# Access Compliance Report

## Public Rights-of-Way

### (Curb Ramps)

Intersection ID: 53804	Main Street: NATHAN_DR	Cross Street: PITZER_DR	Location: SW
ADA ID: 3CAA521E02B9	Ramp Type: Perp	Initial Pass/Fail: Fail	Overall Compliance: No
		Severity Score: 25

#### Codes/Mitigation Info/Possible Solution

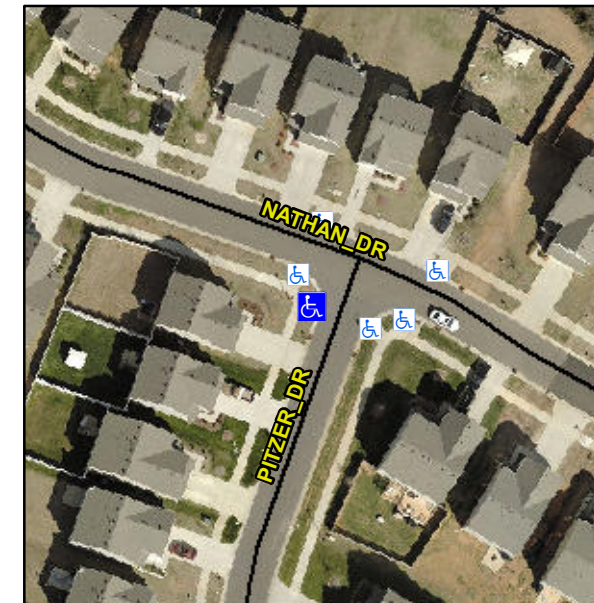
**Not Found, R304.2.2**

Compliance	Description	Data	Compliance	Description	Data
N/A	Ramp Length (in)	97.0	No	Ramp Slope (%)	12.4
Yes	Ramp Width (in)	58.0	Yes	Ramp XSlope (%)	1.5
N/A	Flare Type LT	N/A	N/A	Flare Type RT	N/A
N/A	Flare Slope LT (%)	N/A	N/A	Flare Slope RT (%)	N/A
N/A	Flare Traversable LT?	N/A	N/A	Flare Traversable RT?	N/A
N/A	Landing Length (in)	N/A	N/A	DWS Provided?	N/A
N/A	Landing Width (in)	N/A	N/A	DWS Contrast?	N/A
N/A	Landing Slope (%)	N/A	N/A	DWS Length (in)	N/A
N/A	Landing X Slope (%)	N/A	N/A	DWS Full Width?	N/A
N/A	Landing Curb? (Y/N)	N/A	N/A	DWS Offset (in)	N/A
N/A	Shared Landing?	N/A			
N/A	Gutter Ponding?	N/A	N/A	Gutter Slope (%)	N/A
N/A	Gutter Lip Ht (in)	N/A	N/A	Gutter X Slope (%)	N/A
N/A	Painted X Walk1?	No	N/A	Painted X Walk2?	N/A
	X Walk 1 Direction	To SE		X Walk 2 Direction	N/A
N/A	X Walk 1 Width (in)	N/A	N/A	X Walk 2 Width (in)	N/A
	X Walk 1 Slope (%)	1.1		X Walk 2 Slope (%)	N/A
	X Walk 1 X Slope (%)	0.2		X Walk 2 X Slope (%)	N/A

**Remove & Replace Entire Ramp.**
